**HALL COUNTY BOARD OF COMMISSIONERS
STAFF REPORT**

Request **Variance to Section 9.2.4** | to reduce the required road frontage

Record Number HVAR26-0007

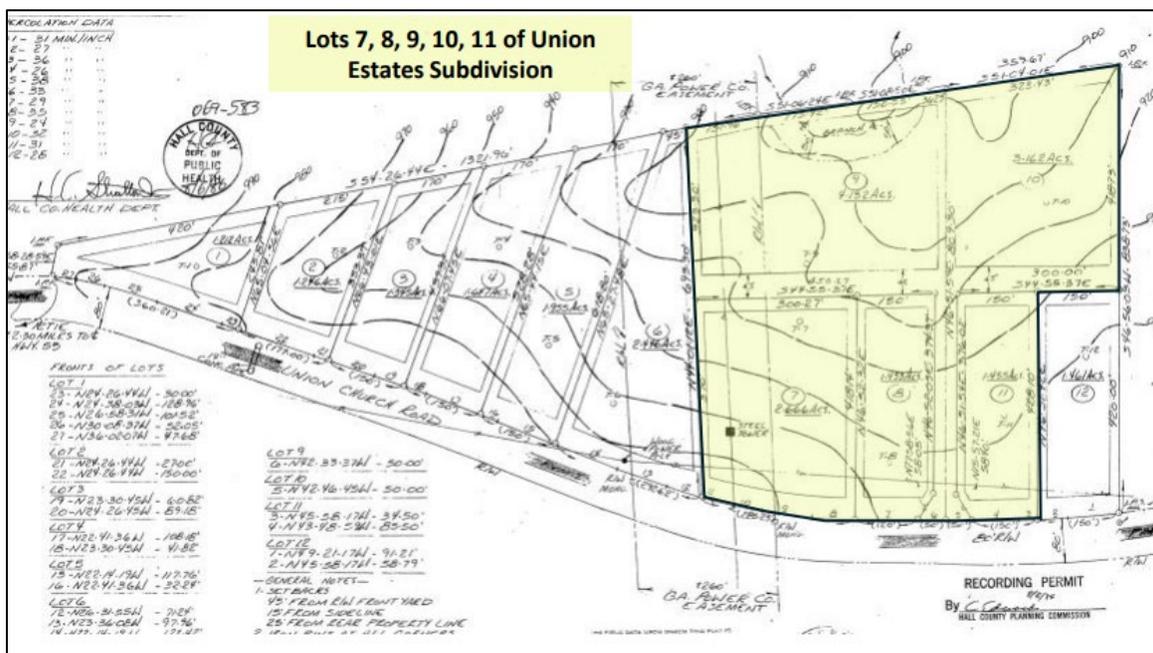
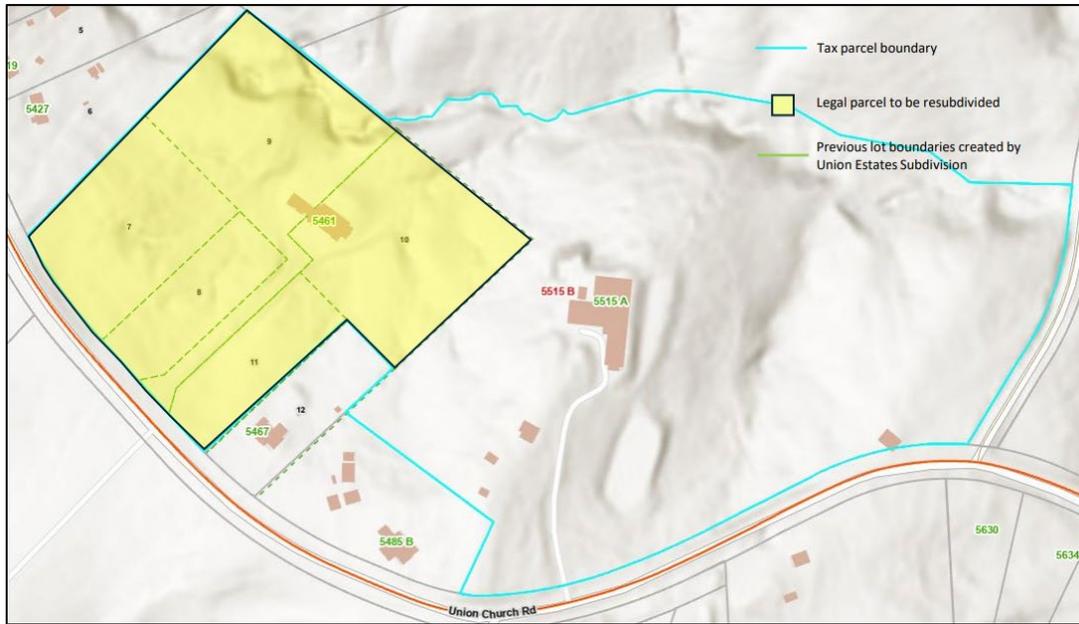
According to the site plan, the residence identified as 5461 Union Church Road, would be located on Tract 5 and would utilize the existing driveway that crosses the proposed Tract 4. All other existing structures would remain on the remainder of the current tax parcel. At this time, there is no proposal to formally establish a common access driveway for Tracts 4 and 5. Creating a common access driveway, however, would eliminate the concern of multiple driveways within a 90-foot span.

The proposed subdivision area corresponds to the former Lots 7 through 11 of the Union Estates Subdivision, approved by the Planning Commission on August 6, 1986. These lots were acquired and combined into one legal parcel and added to the original 29± acres to form the current 38.45± acre tax parcel. As shown on the 1986 subdivision plat, the subject area was divided into five lots with four access points, with Lots 9 and 10 sharing a common driveway. The proposed reconfiguration the former five lots meets all current subdivision standards with the exception of minimum road frontage for Lots 4 and 5. Though not formally proposed by the property owner, providing a common access driveway for proposed Tracts 4 and 5 would replicate the access pattern approved in the original Union Estate Subdivision and achieve the effect of no more than one driveway within a 90-foot span.

1. Tracts 4 and 5 shall be served by a common access driveway, which must be clearly identified on the final plat and referenced in all associated deeds.
2. All conditions of zoning shall be made a part of any plats created for the property.
